APPLICATION NO.	FILING DATE	FIRST NAMED INVENTOR	ATTORNEY DOCKET NO.	CONFIRMATION NO.
09/710,539	11/09/2000	Benjamin N. Eldridge	276440-3	5812

# Office Action Summary

## DETAILED ACTION

ATTACHMENT 1

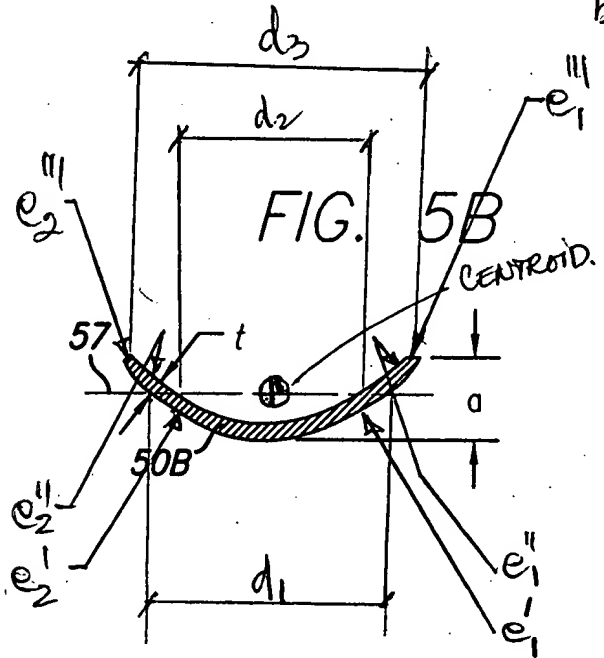
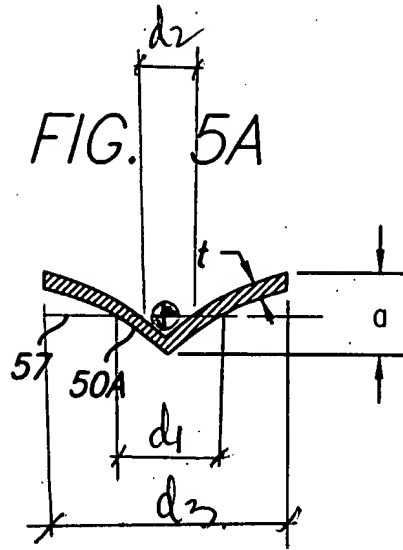
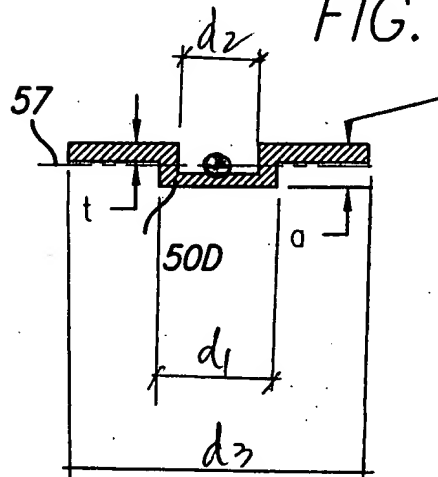
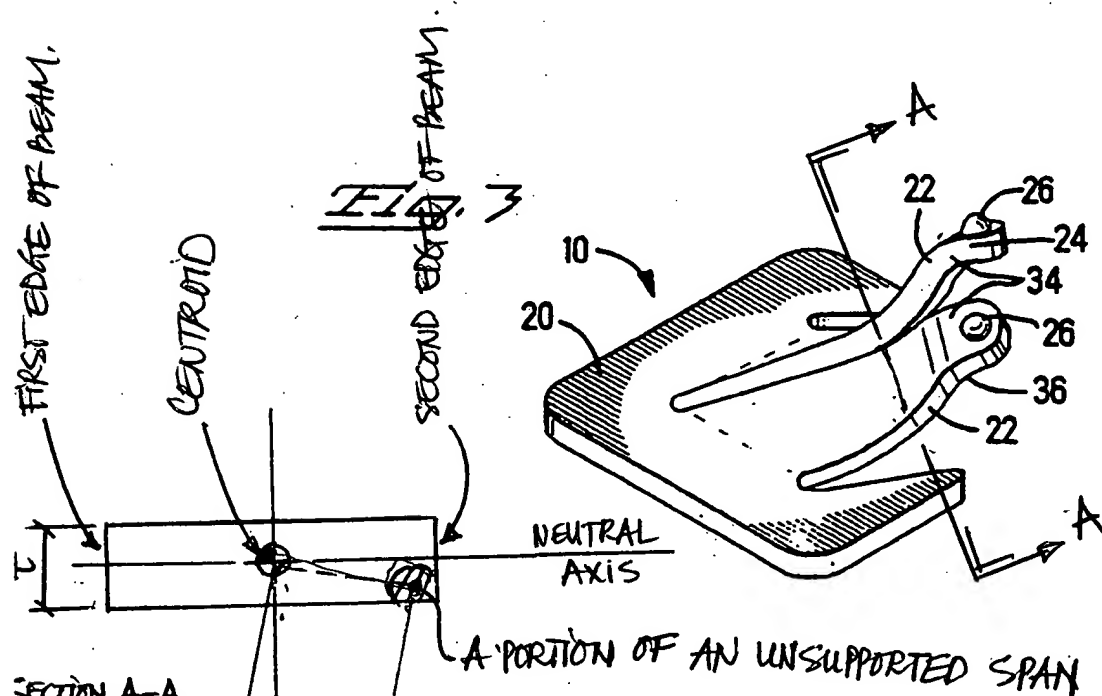
3. Claims 1-21, 25-27, 38-41 and 48-64 are rejected under 35 U.S.C. 112, second paragraph, as being indefinite for failing to particularly point out and distinctly claim the subject matter which applicant regards as the invention.
4. Claim 1, lines 8 and 12-13, it is unclear whether applicant intended by "first edge" and "second edge" of a beam and "said neutral axis running through said first edge, said second edge, and a centroid." Applicant should clarify and define the first and second edges of the beam according to the neutral axis running through said first edge, said second edge, and a centroid. An attachment 1 shows different first edges, second edges and distance therebetween could be defined as  $e'_1$ ,  $e''_1$ ,  $e'''_1$ , and  $e'_2$ ,  $e''_2$ ,  $e'''_2$ , and  $d_1$ ,  $d_2$ ,  $d_3$ .

1) Grabbe et al. fails to discloses a spring contact having a beam "wherein said beam has a length running ... and a centroid of said every cross section" in page 6, lines 2-9. Examiner respectfully disagrees. Grabbe et al. discloses every element of claim 1 (see the rejection

$e_1$  = first edge  
 $e_2$  = second edge  
 $d_i$  = distance between edges

ATTACHMENT 2

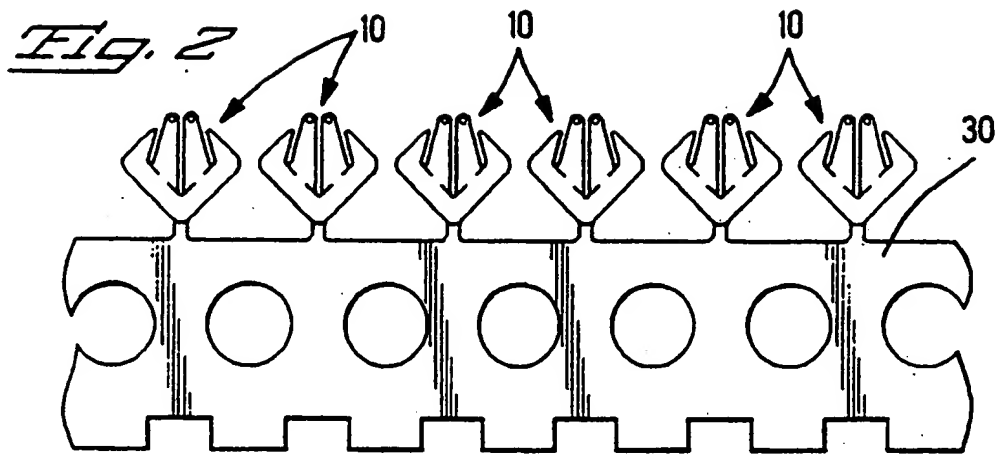
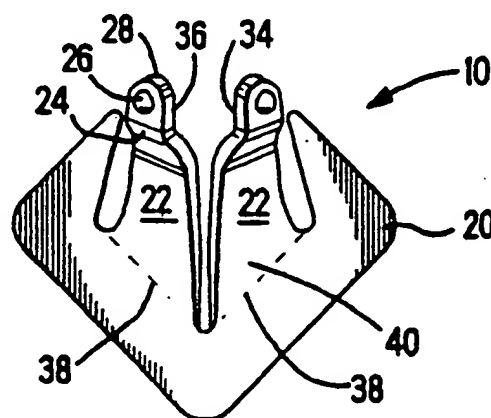
described above and the analysis in the attachment). Grabbe et al. also discloses the newly claimed a distance extending from a neutral axis to a portion of an unsupported span of a beam is greater than one-half of a thickness of the beam (see attachment 2), as claimed.

$t$  = UNIFORM THICKNESS.  
 $d$  = DISTANCE EXTENDS FROM  
 A NEUTRAL AXIS @ CENTROID  
 TO A PORTION OF AN  
 UNSUPPORTED *FIG. 4*  
 SPAN.

$$d > \frac{1}{2} t$$
